Residents of Crestview Court – Plateau East Subdivision

Signed Petition Received by the Clerk's Department –
June 11, 2018

Plateau East Subdivision is comprised of 39 lots. Of the 39 lots, 37 property owner's support the deletion of a proposed “gravel walkway” on Crestview Court.

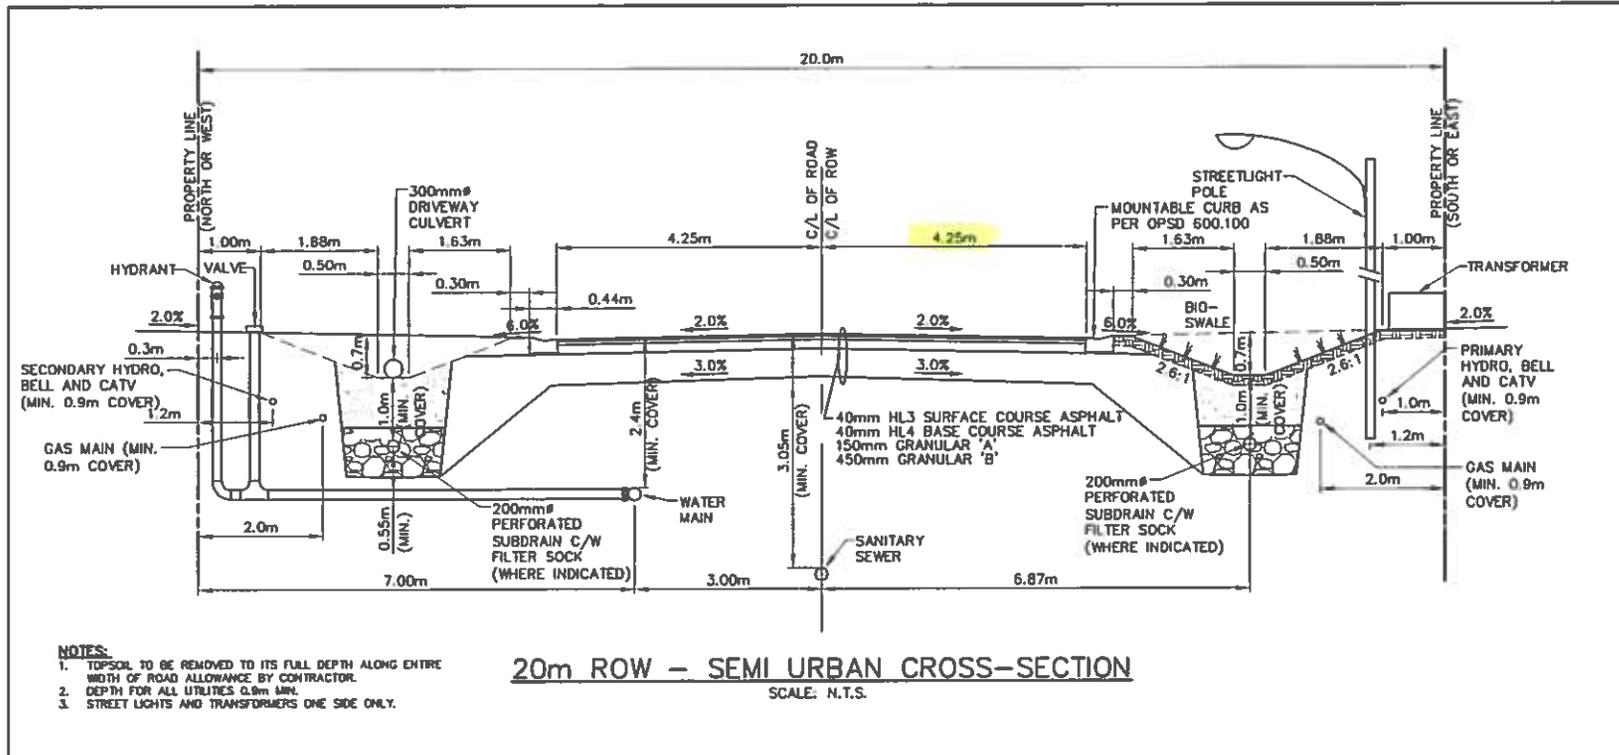
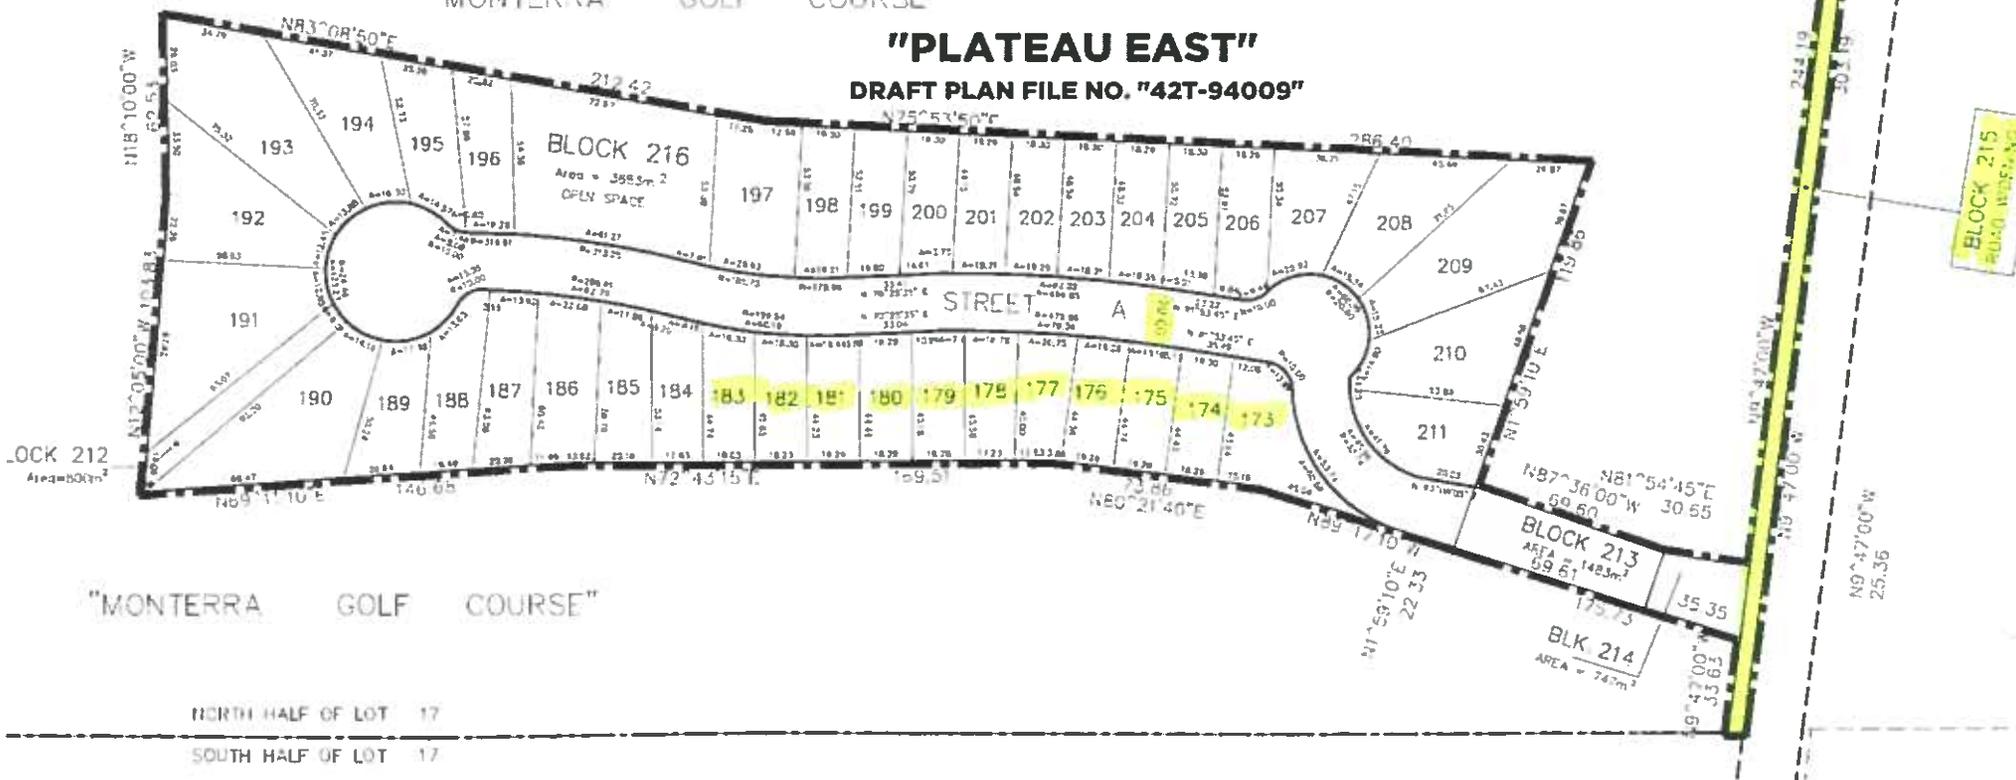
Firstly, in a report to Council, staff recommended a reduction in the minimum front yard setback from 7.5m to 6.0m for Blocks 173 to 183 or Lots #1 to #11 inclusive (see attached plan). The net effect of this decision for these particular lots is that we are now limited to 6.0m deep driveway (assuming that the garage is built to the minimum dimension permitted), which is basically the depth of a traditional parking stall found at any parking lot. For those owners with larger vehicles and/or rear bike mounts attached to their vehicle, there is a strong likelihood that the tail end of the vehicle and/or bike rack will project into the pathway of the bike trail. The bike path should not be adjacent to lots where the minimum front yard setbacks were reduced to 6.0m.

The initial plan of subdivision application had a 20.0m wide ROW, designed to semi-urban standards (see attached cross-section). This cross-section accommodated a **8.5m wide road** with no trail surface. The approved and as constructed cross section changed the 20.0 ROW to a 6.0m wide road with 1.5m wide shoulders on each side for a **total road width of 9.0m**. Included in the ROW was a 1.5m trail surface. This raises the question as to why staff recommend and/or approved a rural urban design vs a semi urban design. The Towns OPA general policies for roads (Section 7.2(4)) state ***"To facilitate the safety and maintenance of the road system, it shall be policy of this plan that all developments or new land use provide adequate off-street parking"***. In my opinion this policy is at risk with the decision to place a bike trail along the southern edge of the ROW, where homes are located only 6.0m away with cars taking up the full 6.0m depth of driveway. Furthermore to keep the trail clear of vehicles, any resident parking a second car on the north side of the trail will in all likelihood force the second vehicle onto the paved shoulder or perhaps the pavement. If the intent of the policy is to keep cars off the roads then this design fails.

Sections 6.2(3) & 6.2(6) goes on to state ***"development agreements shall provide for the dedication to the municipality of new public pathways in accordance the Town's engineering standards"***; ***"Paved or concrete pathways shall generally be required for internal walkways within a subdivision areas"*** and finally ***"The location and design of pathways shall be..... shall generally be a minimum of 6 metres in width"*** The 1.5m limestone screenings "trail surface" running along the south side of Crestview Court falls short of many of these parameters.

In my opinion the Town had an opportunity to create a bike path route by incorporating a bike lane into the semi urban ROW design with a painted/dedicated 1.5m wide stripped bike lane as part of the overall 8.5m wide paved road. I was recently involved in an business park sub-division project in Oakville, where bike lanes were added (see attached photos) just prior to assumption of the road that services

Work on the proposed trail surface should be stopped and the concept of a pathway be re-visited. The road has not been assumed and the final lift of asphalt is at least another year or two away, so now is the time to re-visit this decision. If a 6.0m wide road can accommodate the local traffic, then why not make use of the paved shoulders to create a bike lane. By adjusting the centre line of road and making use of the current shoulders, a bike path can easily be incorporated into the road system with minimal and/or no additional cost. The removal of the trail surface will also result in a much safer environment for cyclists and/or those using the trailer especially with respect to lots 1-11.

Sorry for not getting back to you sooner. There is certainly merit in your observations and, I think, elimination of the trail and creating bike lanes on the roadway could be supported by staff if we received such direction from Council. The reason why we would need Council direction is that the trail was part of the Master Development Agreement that proposed linkages amongst all the development backing on to the Monterra Golf Course.
